PERMIT

SEWAGE DISPOSAL SYSTEM

HOWARD COUNTY HEALTH DEPARTMENT

PURPOSE - to upgrade an existing septic system to accommodate a proposed addition - BP#47660.

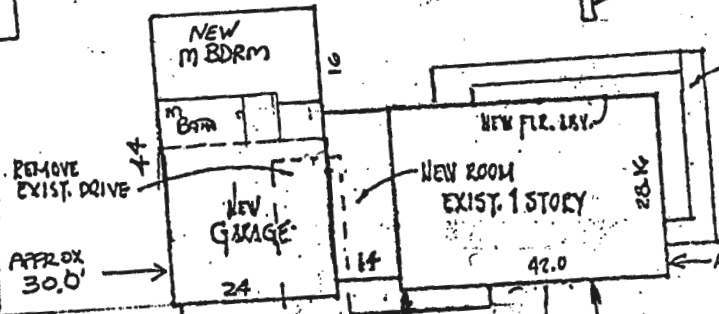
PLAN HAS BEEN REVISED
ONLY 1 BR ADDITION
NO PHYSICAL IMPACT
NO NEED TO EXPAND SYSTEM AT THIS TIME
INS OF NEW HOUSE IS NEEDED

SITE PLAN

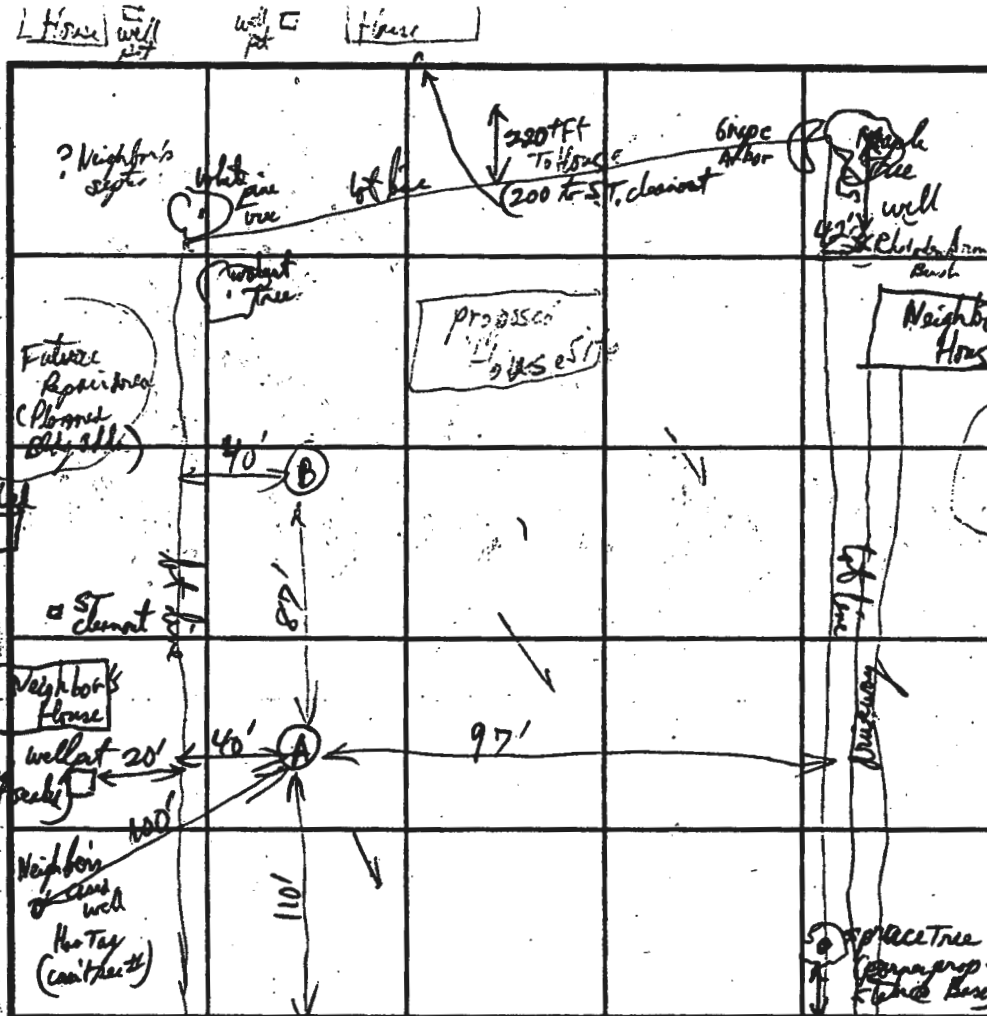
NO IMPACT TO
WELL & SEPTIC
(NEW HOUSE CONNECTION)
ALLOWED

7/16/96
MET OWNER

@ SITE HE
AGREED TO
FILL WELL W/
CEMENT @ TIME
SEPTIC TANK APPROX. OF NEW
SHED CONSTRUCTION
OK TO ALLOW PIT
STRUCTURE TO REMAIN
DRILLED WELL
IN PIT

OK TO SIGN
MR
